Addendum #1

Richmond Community College Hendrick Center for Automotive Training 1042 West Hamlet Avenue Hamlet, NC 28345

ADW Project Number: #23014

FLOOR PLAN 1/8" = 1'-0"

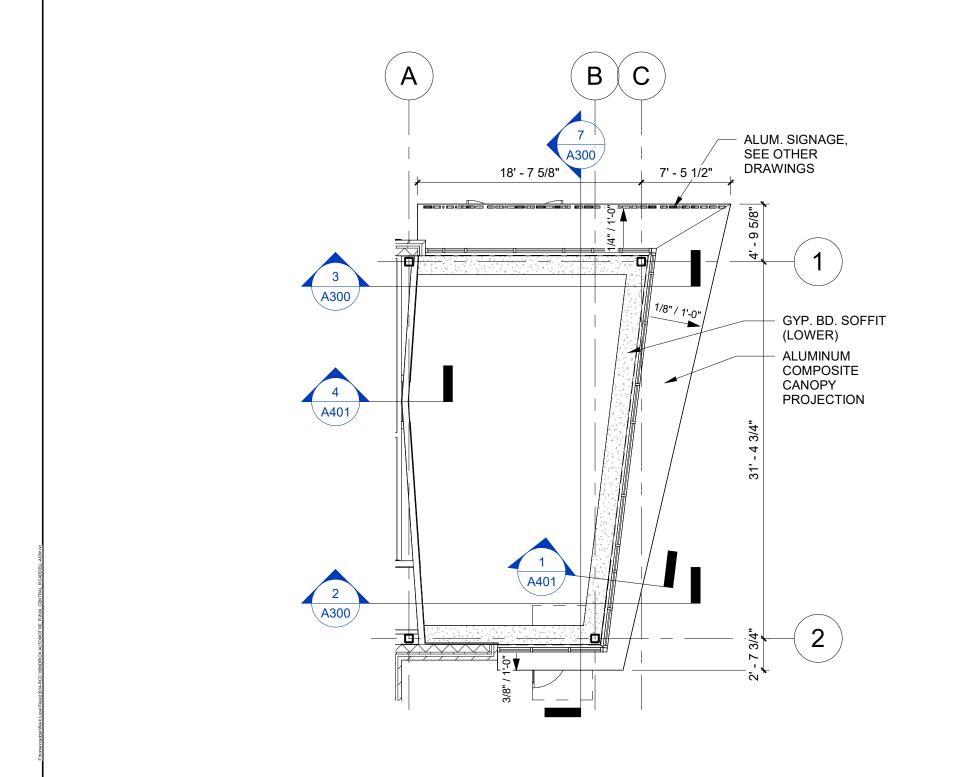
- 1.) C300 and C301
 - a. Revised to include temporary construction fence.
- 2.) S001
 - a. Revised note 4.4 under Foundations.
- 3.) A100
 - a. Added concrete housekeeping pad under compressor and air dryer in Equip Stor 113.

- b. Added tags to storefront in Admin 102.
 - c. Added General Note #7 regarding wall furring.
- 4.) A110
 - a. Detail 2: Revised downspout size in note.

A110

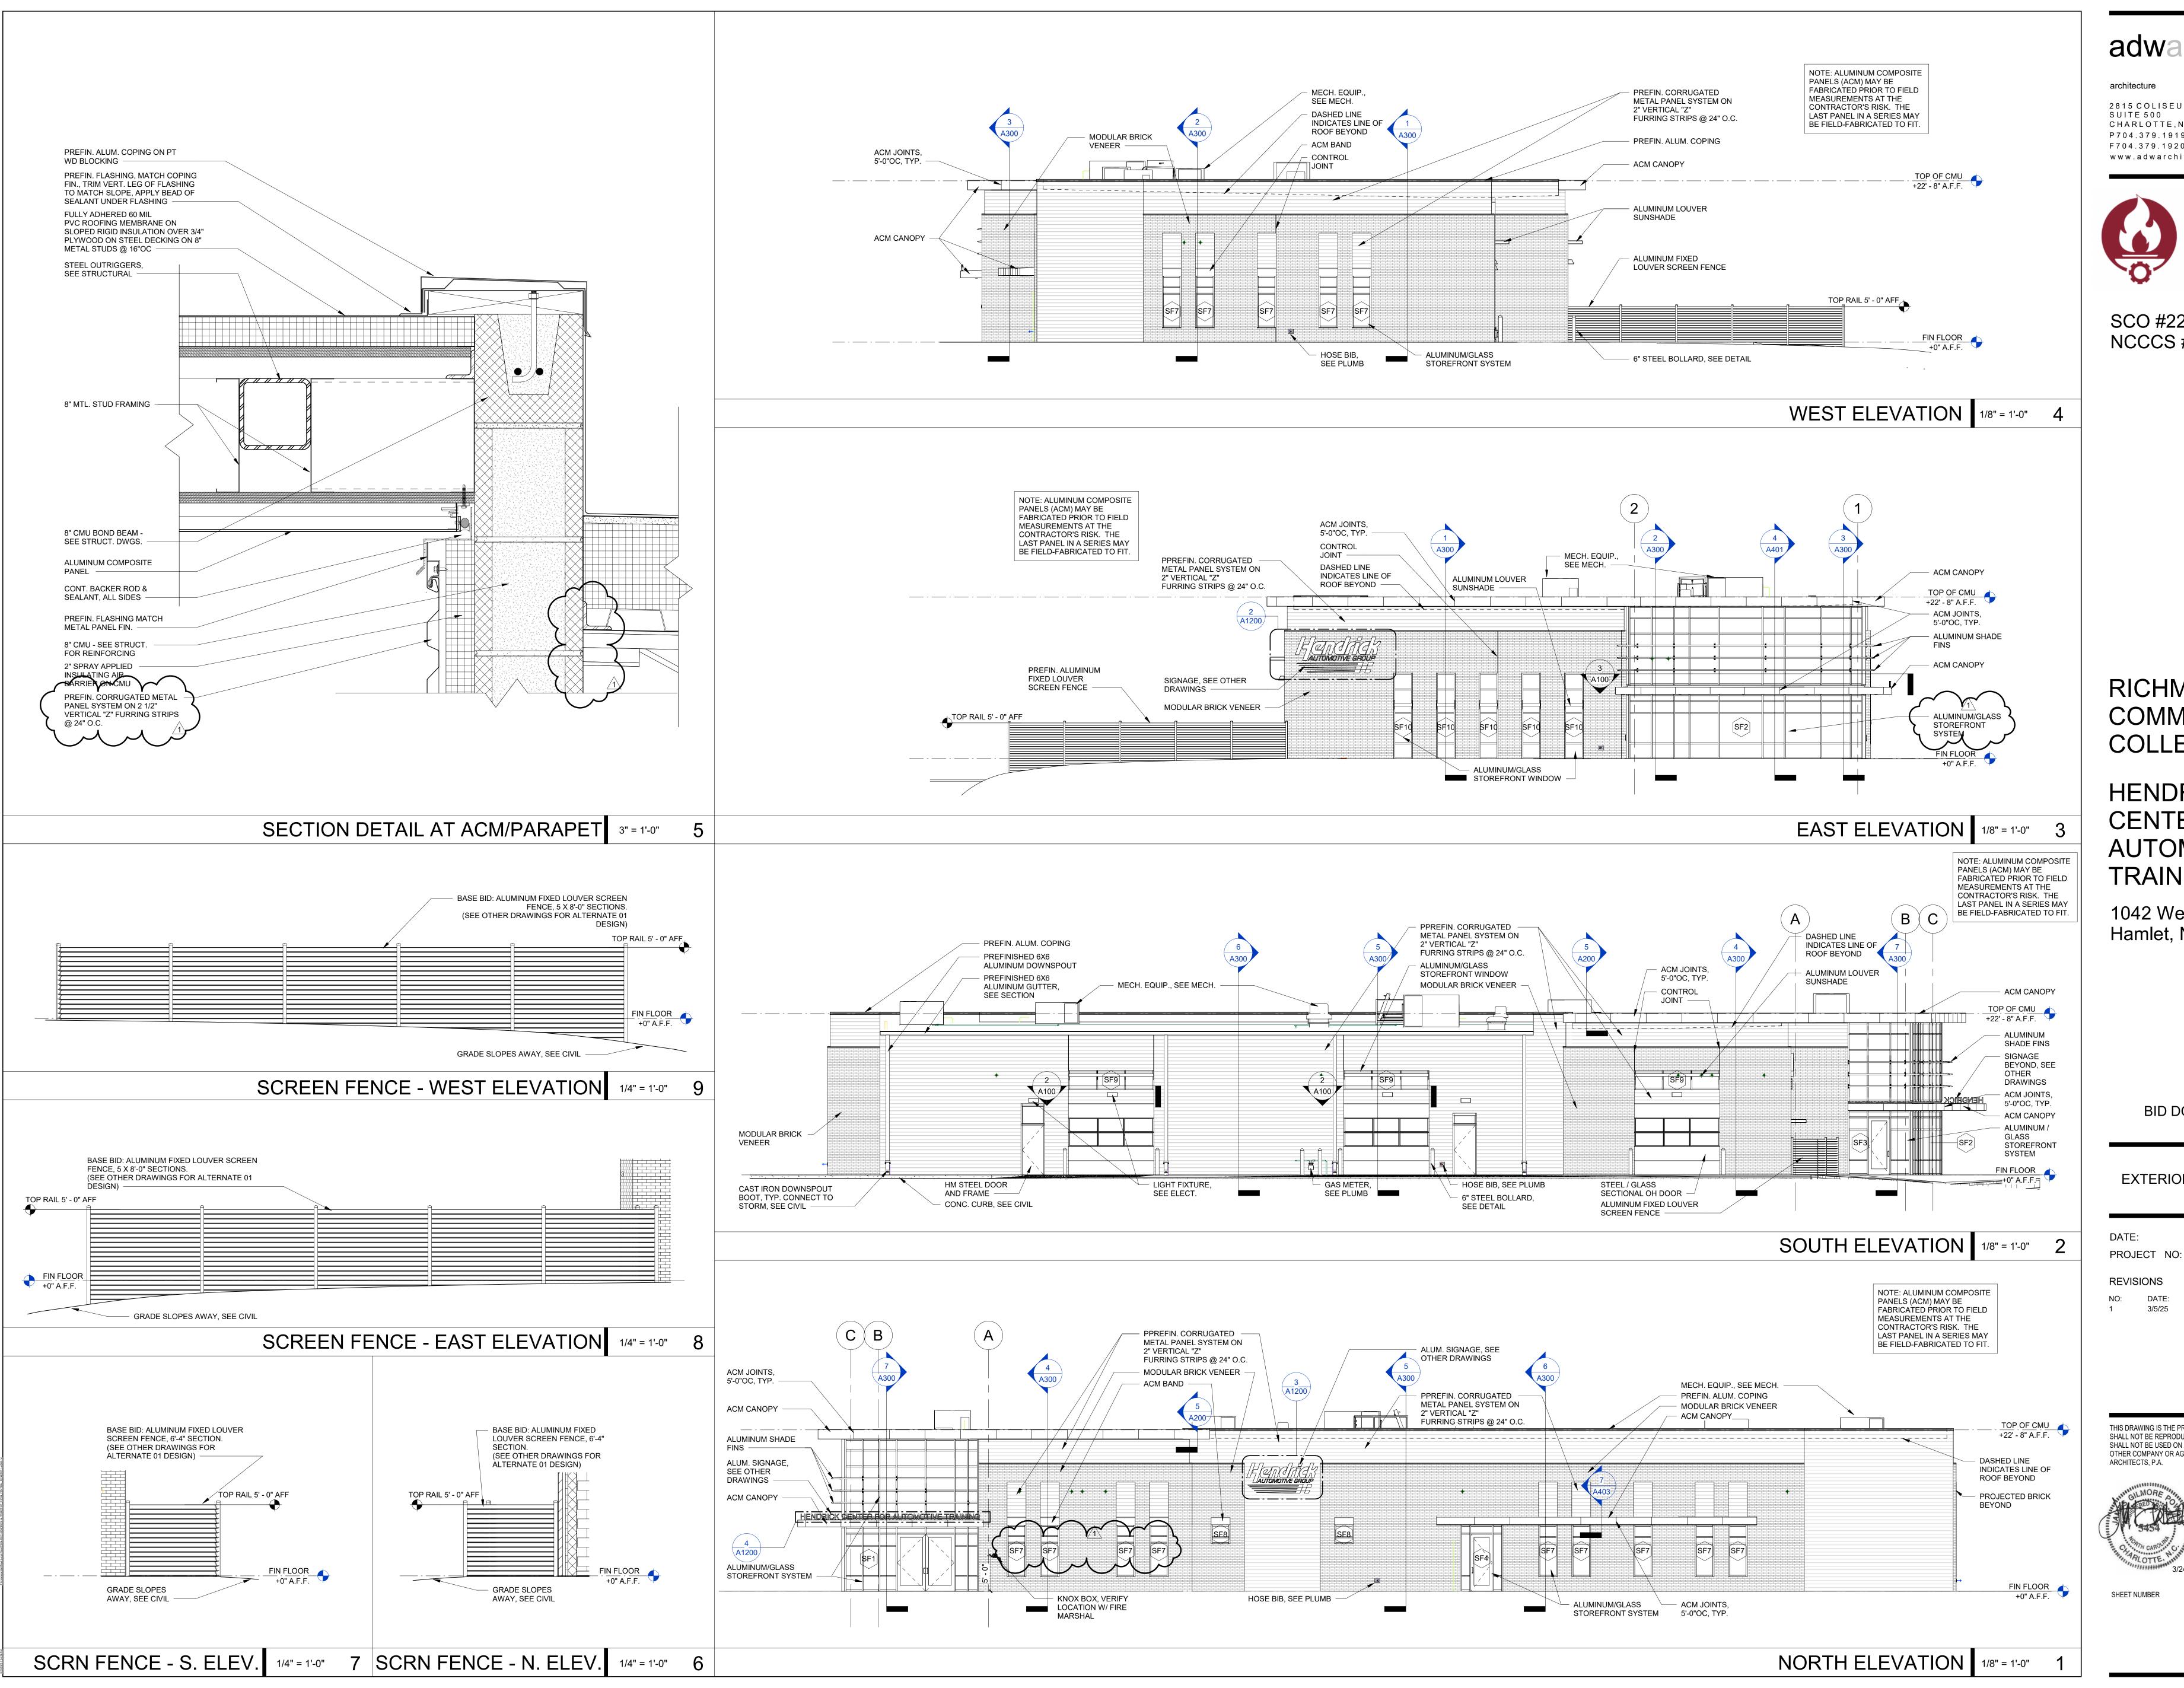
- 5.) A200
 - a. Detail 1: Added tags to storefront in Admin 102.
 - b. Detail 3: Revised note to say storefront instead of curtain wall.
- 6.) A110, A200, A400, A401, A402, A403, A404, A501: Exterior wall sections and details.

- a. Z-furring strips behind exterior corrugated metal wall panels changed to 2 ½".
 - b. Where interior furring of exterior walls is shown, change 1" Z-furring strips to 2" and delete rigid insulation. Also, stop gypsum board and furring 6" above finished ceilings. Only the exterior walls of the toilet rooms will have 1" Z-furring strips, also without insulation and stopping furring and gypsum board 6" above ceiling.

A401

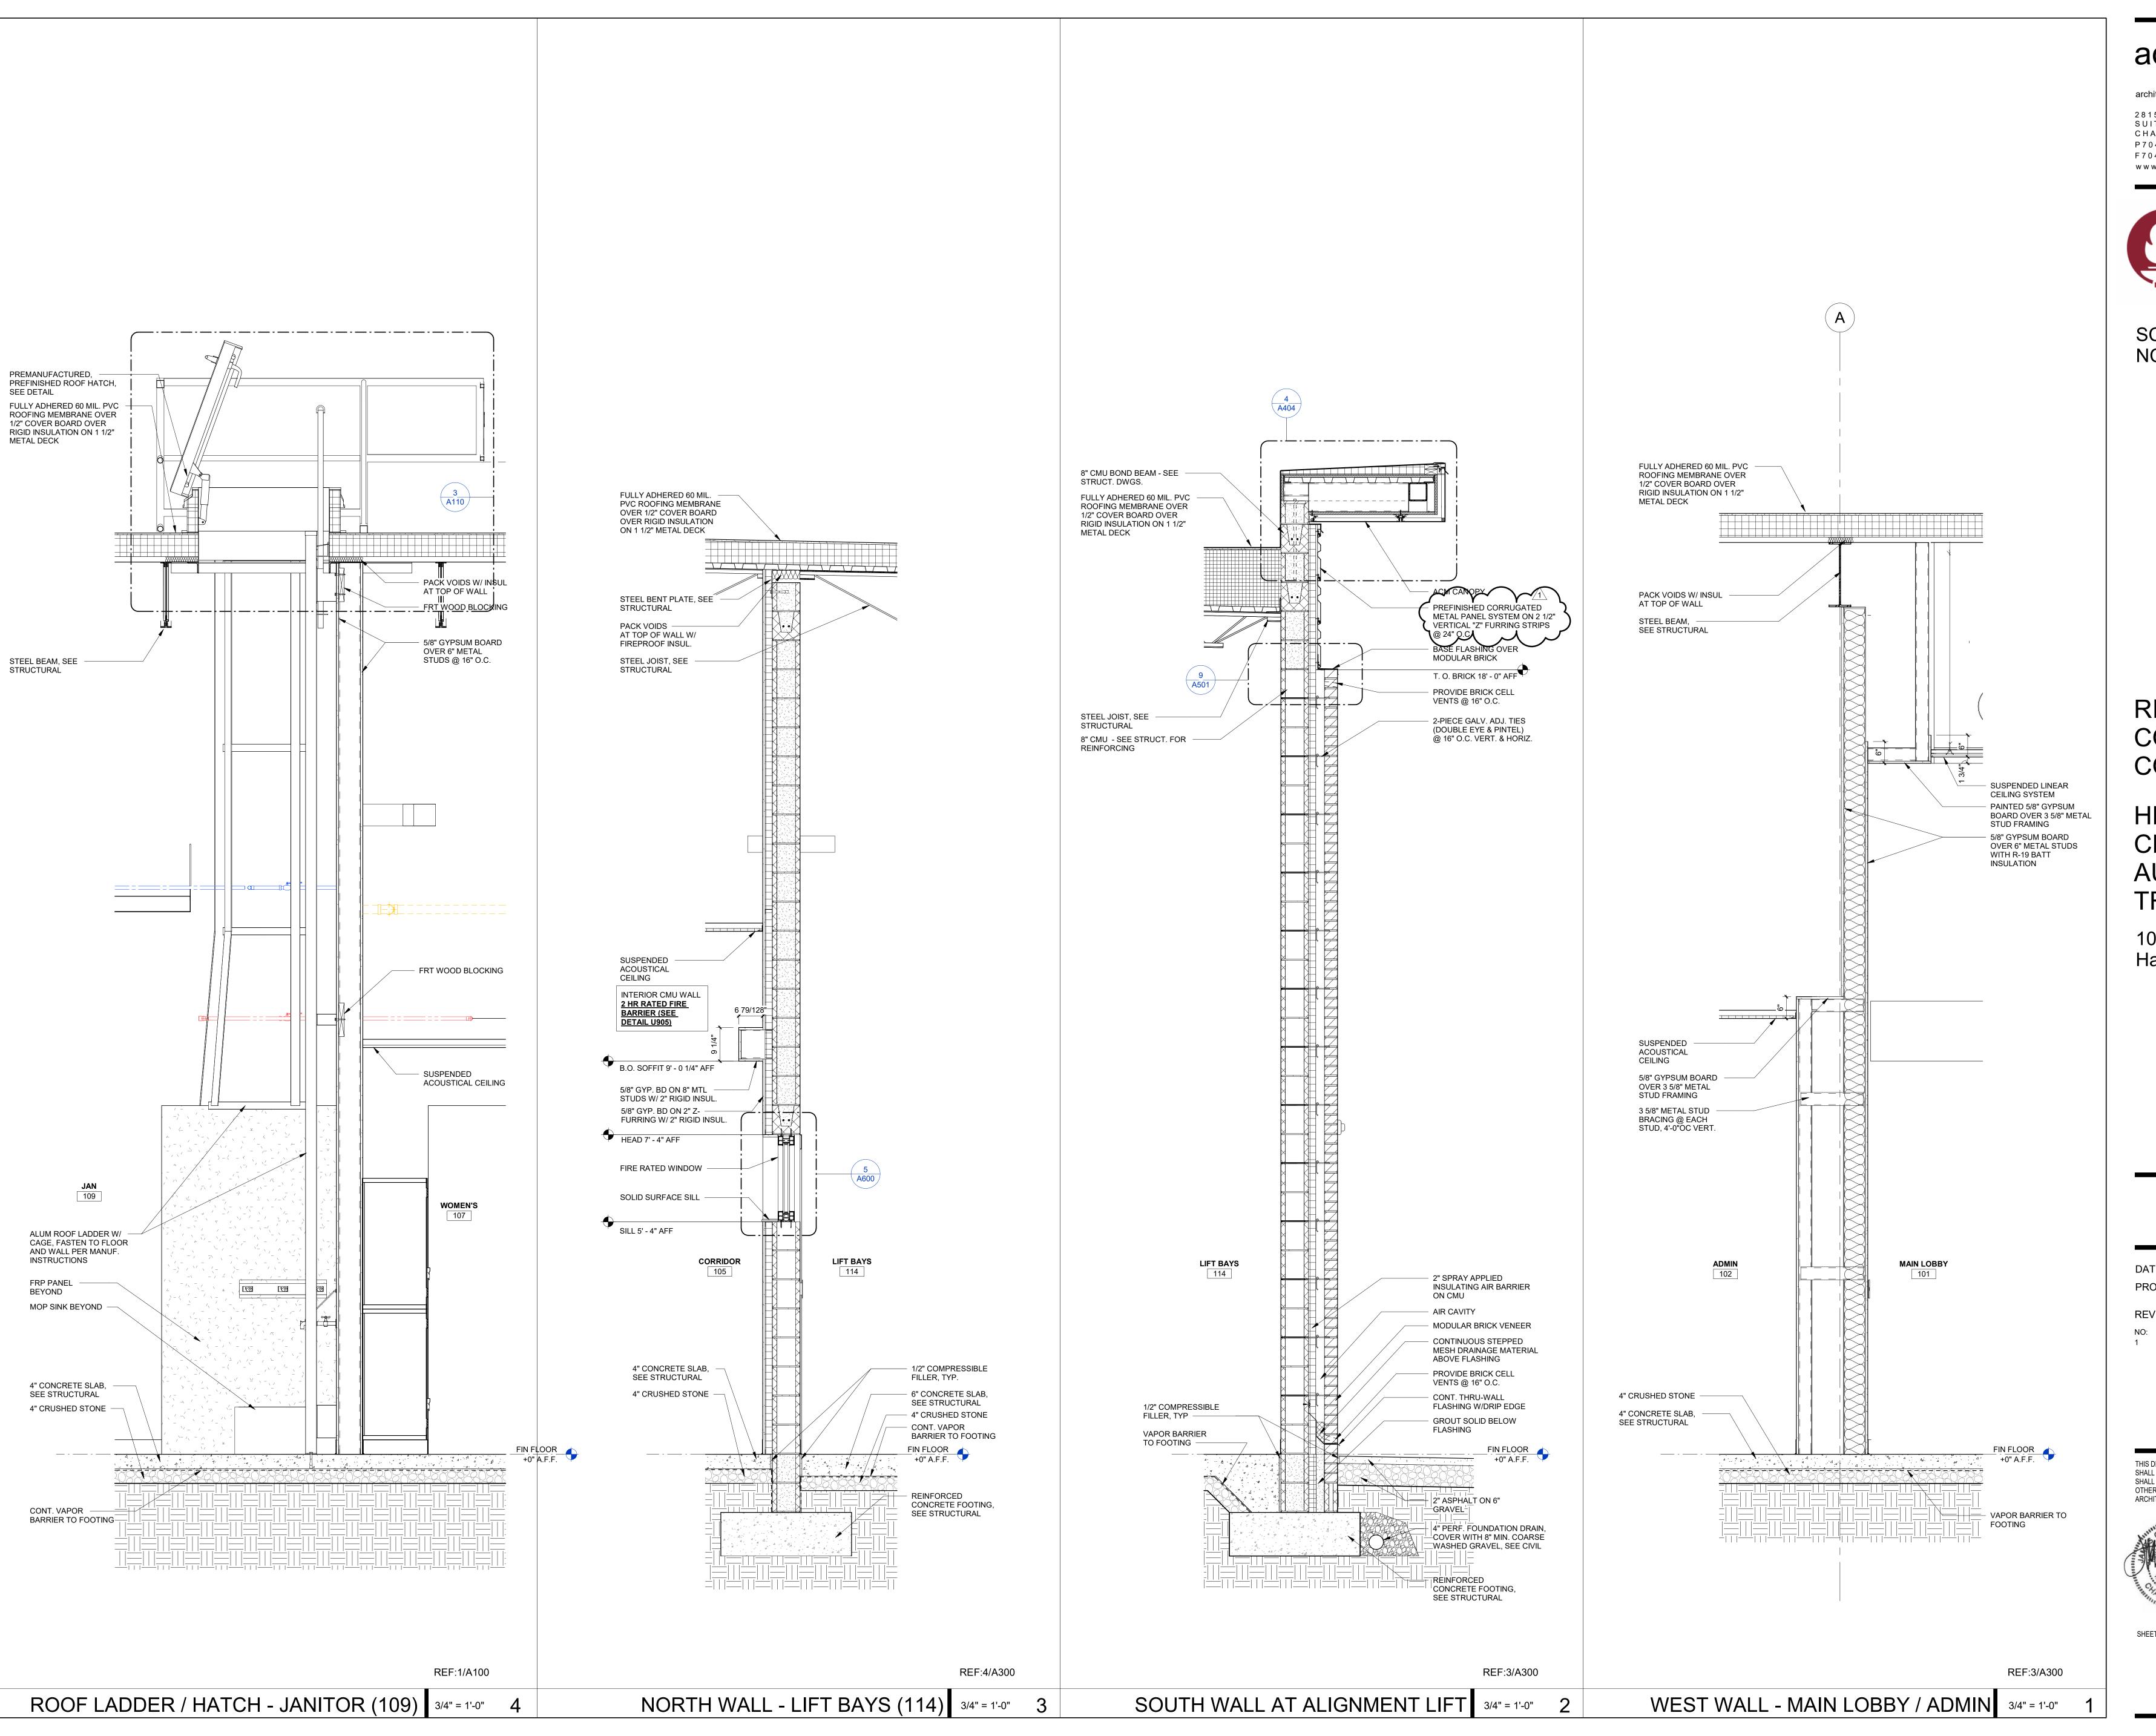
- 7.) A401
 - Detail 7 added to show canopy signage attachment.
- 8.) A404
 - a. Detail 1: Steel angle added to storefront sill detail.
 - b. Detail 9: Drainage mesh shown in front of flashing down to weep.
